APPLICATION NO.	FILING DATE	FIRST NAMED INVENTOR	ATTORNEY DOCKET NO.	CONFIRMATION NO.
10/728,848	12/08/2003	Kwang Hyun Kim	40296-0043	9273

DETAILED ACTION

For: INTERNAL VOLTAGE GENERATOR OF SEMICONDUCTOR DEVICE COMPRISING
CHARACTERISTIC CONTROLLER

Fig. 1
(Prior Art)

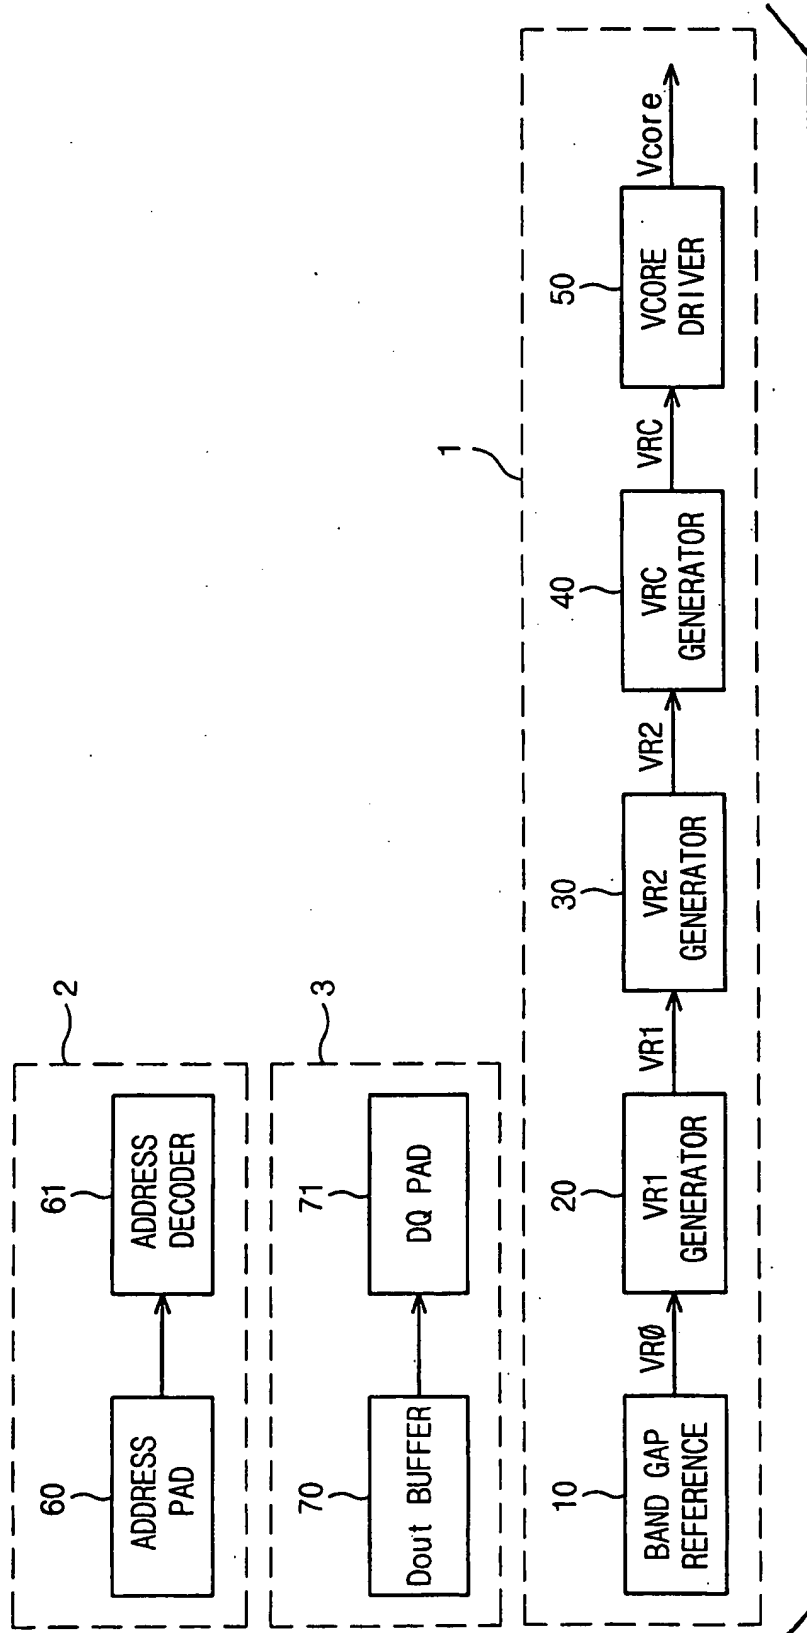
The drawing changes, and some associated changes to the disclosure and comments with respect to Fig. 1, overcame the objections to the drawings as described in the previous Office Action. Therefore, those objections have been withdrawn.

Transmitted herewith are replacement sheets for Figures 1 and 8 (2 sheets), for the captioned application. Figure 1 has been amended to include a bracket to embrace the separate parts, in accordance with 37 C.F.R. § 1.84(h)(1), and Figure 8 has been amended to replace reference number "40" with reference number --50--, in accordance with the Examiner's helpful suggestion. The Official Draftsperson is respectfully requested to approve this drawings for entry into the application.
